A Review of the Limerick Generating Station Severe Accident Risk Assessment

Review of Core-Melt Frequency

Brookhaven National Laboratory

Prepared for
U.S. Nuclear Regulatory
Commission

Figure 2.1.1 Crust Block source zone used in the LGS-SARA (taken from Appendix A, Figure 5 of LGS-SARA).

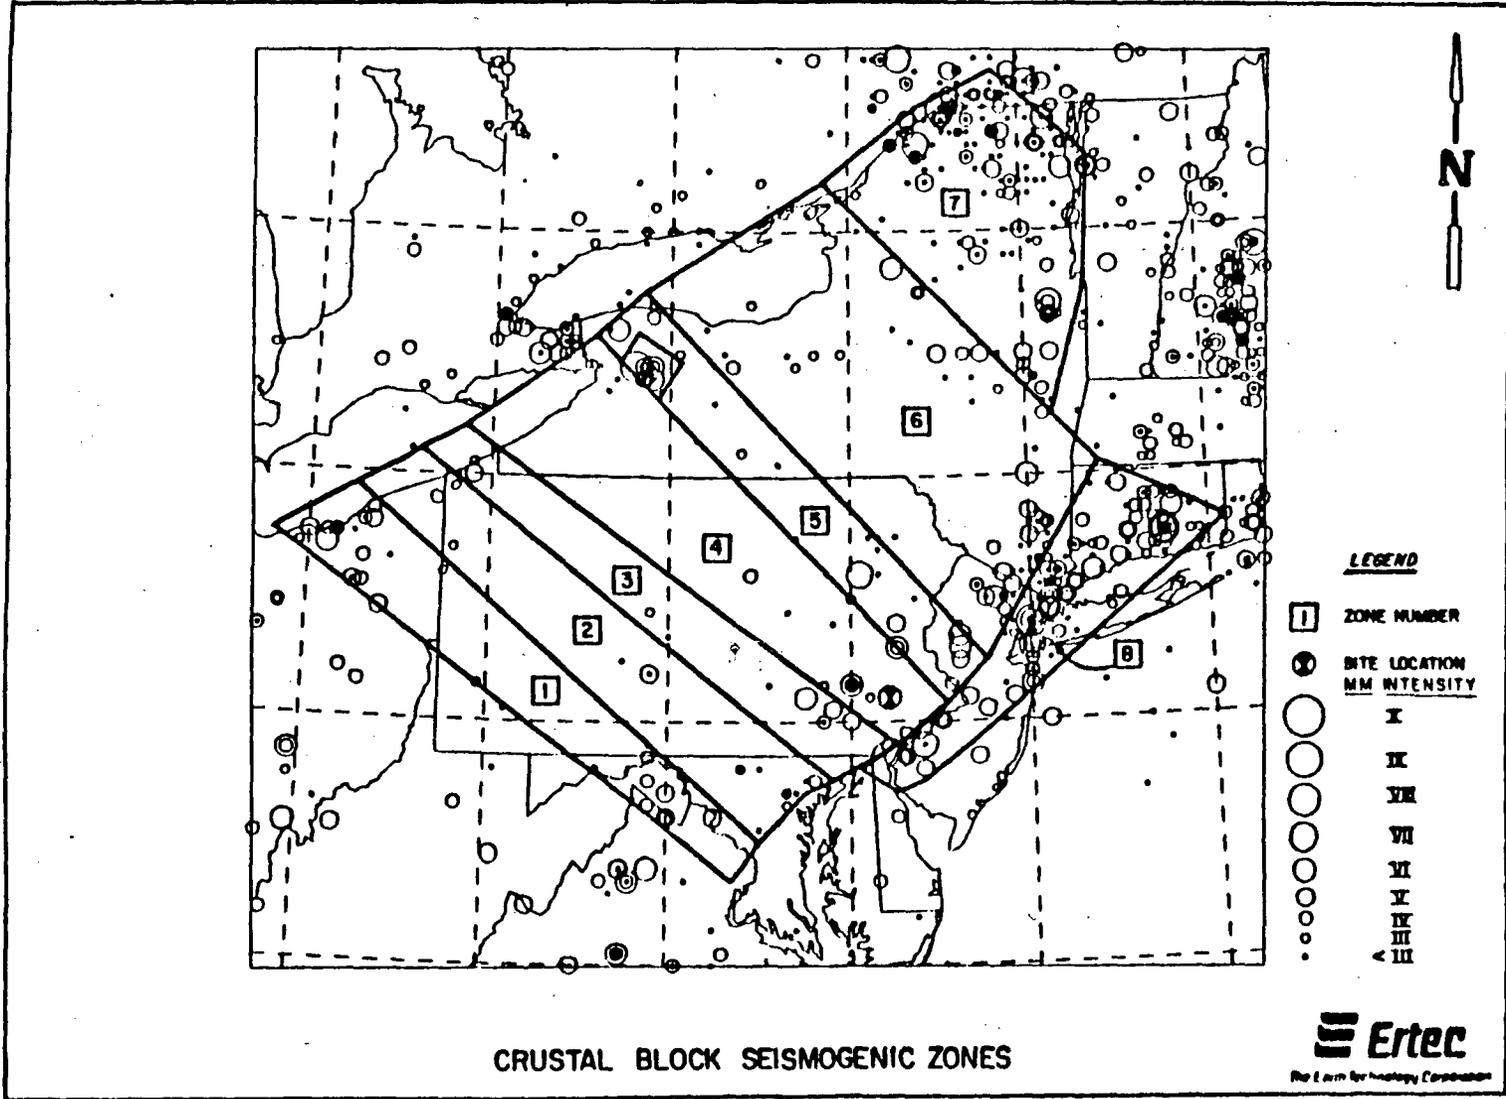
As stated previously, Zone 8 is reported to have the greatest contribution to the site hazard. A review of Figure 2.1.1 indicates that the closest proximity of Zone 8 to the LGS-SARA site is approximately 30-40 miles. This fact alone explains to a large extent why the hazard curves derived for the Crustal Block hypothesis produced the lowest frequencies. It is further noted in Figure 2.1.1, which also shows the distribution of seismicity to 1980, that the northwest boundary of Zone 8 appears to be inconsistent with the pattern of earthquake occurrences in southern New York, New Jersey, and eastern Pennsylvania. At the meeting at SMA, it was learned that Zone 8 was modeled to represent the Triassic Basin. The inconsistent delineation of Zone 8, with respect to local seismicity patterns, may be attributed to two factors. The LGS-FSAR⁽⁶⁾ reports that Limerick is in the Triassic Lowlands, suggesting that the northwest boundary of Zone 8 should be moved toward the plant. This would also be consistent with the distribution of seismic events in the region (see Figure 2.1.1).

With regard to seismogenic zones, two major concerns were raised. First, delineation of the boundaries of the Crustal Block hypothesis was questioned. In particular, Zone 8 in this model was considered inappropriately defined to be approximately 30 miles from the LGS at its closest point. The impact of redefining Zone 8 on the mean frequency of core melt was considered to be small. Secondly, the Decollement source was used as an all-inclusive model to consider the general hypothesis that large-magnitude events can occur in the east. This approach was not considered to be the most reasonable means of evaluating the hazard due to such hypotheses. An alternative was recommended that allows the possible occurrence of large-magnitude events to occur on the other source zones as well. The impact of this alternative on the mean core melt frequency was considered to be small.

A redefinition of Zone 8 in the Crustal Block hypothesis that places the LGS site within its boundaries is judged to have a moderate impact on the estimated hazard curves (i.e., at least a factor of 2). The consequences of this change on the mean frequency of core melt is estimated to be small (i.e., a factor of 2 or less). However, a moderate increase in the median core melt frequency is considered possible.

Figure 3.1.2 Reduced fault tree for failure to scram.

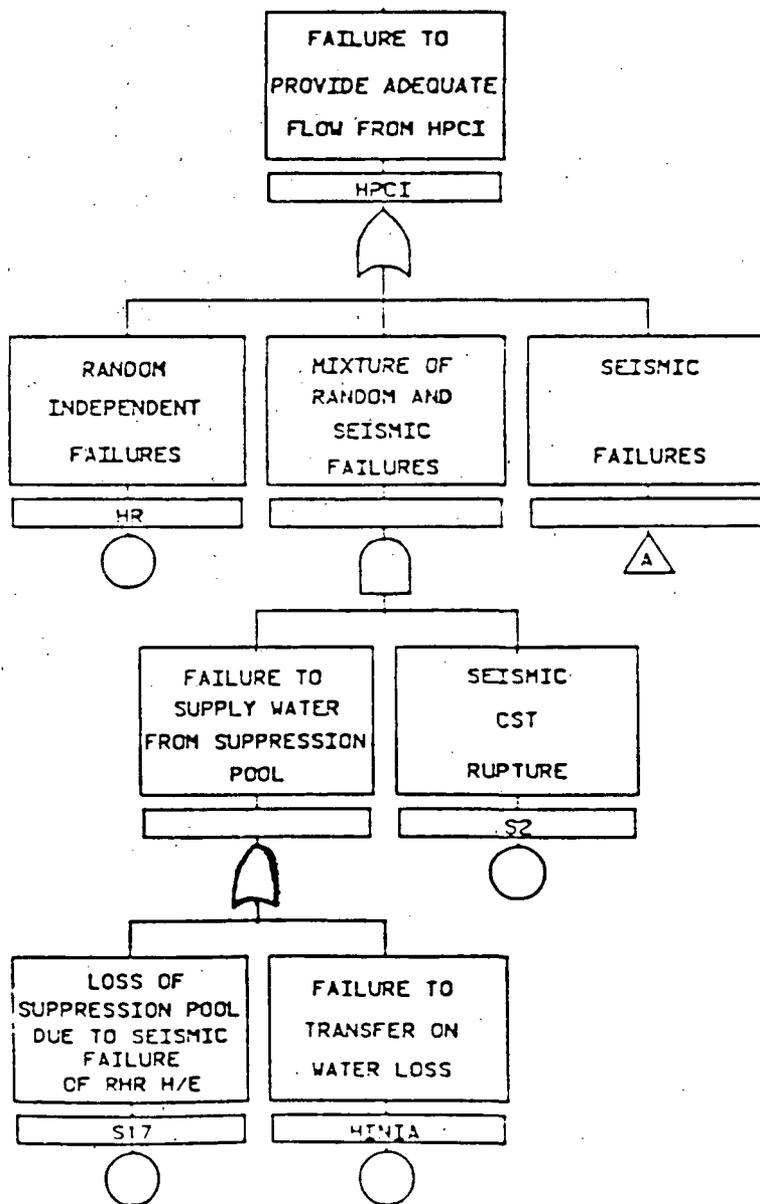
A telephone conversation with PECO revealed that the PC_R is a judgmental factor applied to the seismic failure of the reactor internals and CRD guide tubes (see Figure 3.1.2). PECO stated that failure of the CRD guide tubes or the reactor internals due to an earthquake would cause a failure to scram only 20 % of the time. Since information on how this PC_R value is obtained is incomplete, it is difficult for BNL to judge its validity.

Figure 3.1.3 The seismic event tree.

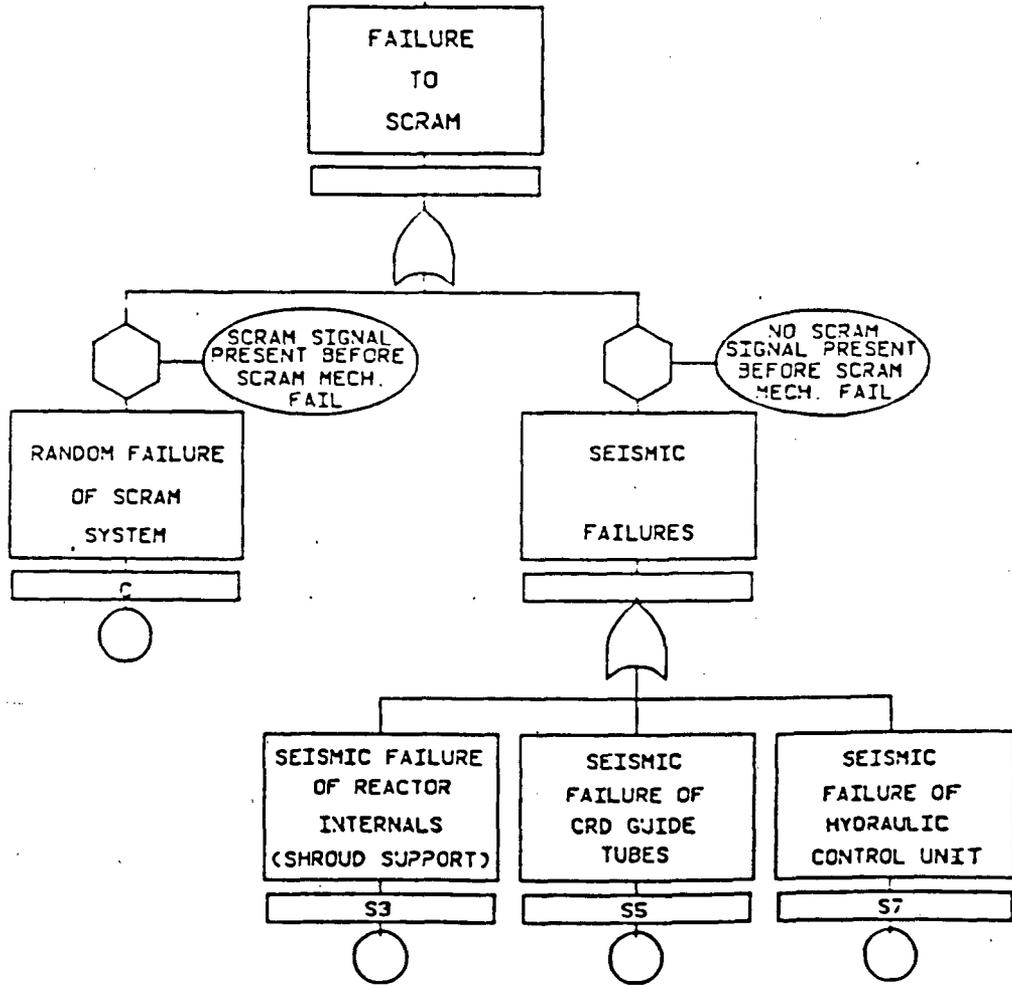
In Figure 3.1.3, the event T_S , sequence number 1, was treated as an OK sequence. A note at the bottom of the figure states that a seismic event that does not lead to the loss of offsite power is considered to be benign and is adequately accounted for in the turbine-trip-initiating event.

If, in an earthquake, offsite power is still available, the event tree presented in Figure 3.1.3 does not model the plant response beyond that point. In principle, according to the event tree, the reactor is not even scrammed and, therefore, there is no need for it to be transferred to the turbine-trip

event tree. However, if there is failure of non-safety equipment or tripping of the equipment offline which results in a plant transient, such as the loss of feedwater, then the event tree should be further developed to define the accident sequences. The internal event turbine-trip event tree is not appropriate since the mitigation system considered will not include the necessary seismic failures. The new event tree will be similar to the one in Figure 3.1.4 with certain random failure values modified to reflect the availability of offsite power. BNL estimated that by transferring T_S to this new event tree, the only sequence which may contribute to the overall core damage would be T_SUX . The core-damage probability is estimated to be in the order of 10^{-7} to 10^{-8} .

If, in the reactor transient, there is a failure to scram, an event tree similar to Figure 3.1.5 should be developed. It is conceivable that the contribution to risk due to Class V sequences may not be negligible. It is recommended that these considerations of additional accident sequences should be addressed in the LGS-SARA.

Figure 3.1.5 Seismic event tree for loss of offsite power without scram.

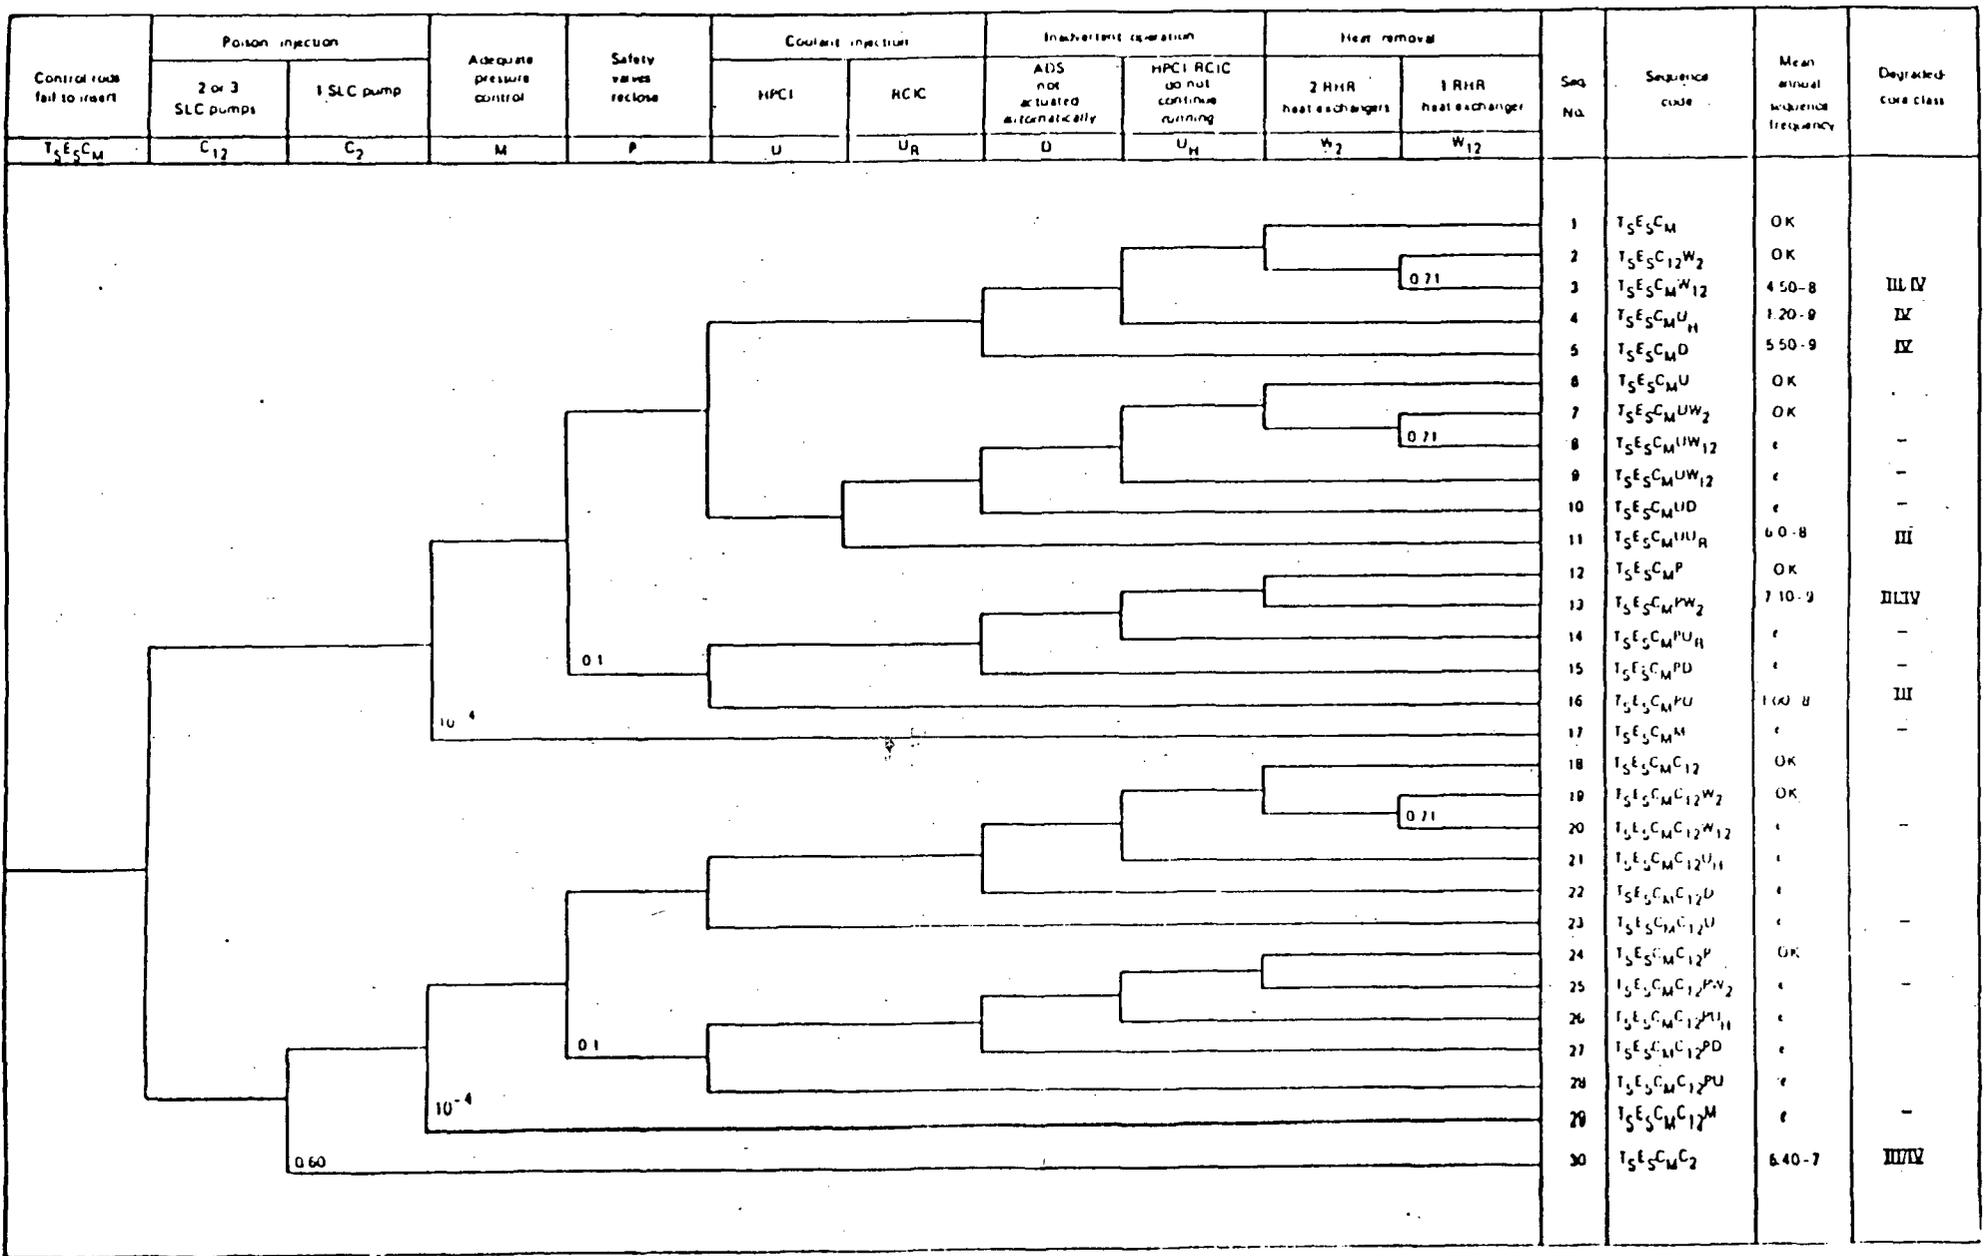
BNL reviewed the LGS-SARA ATWS event tree and found that, in addition to those two dominant ATWS sequences, $T_S E_S C_M C_2$ and $T_S R_B C_M$, the contribution to core damage from other ATWS sequences defined in Figure 3.1.5 is relatively small. However, with the BNL definition of C_M , there will be about a factor of 5 increase for all the ATWS sequences in Figure 3.1.5. The total ATWS core-damage frequency reported in LGS-SARA is 8.1×10^{-7} ; by eliminating the PCR and using the BNL C_M definition, the total ATWS core damage becomes approximately 4.0×10^{-6} . This does indicate that the ATWS results are quite sensitive to the parameters used to define the failure of scram. PECO believed that it is conservative in assuming that those failure modes defined for the reactor internals and the CRD guide tubes will directly cause a failure to scram. BNL tends to agree that the definition of failure modes of these components may be conservative and would encourage additional analysis to support the LGS-SARA assumptions. A refined analysis in this area is needed since it will have significant impact on the acute and latent fatalities.
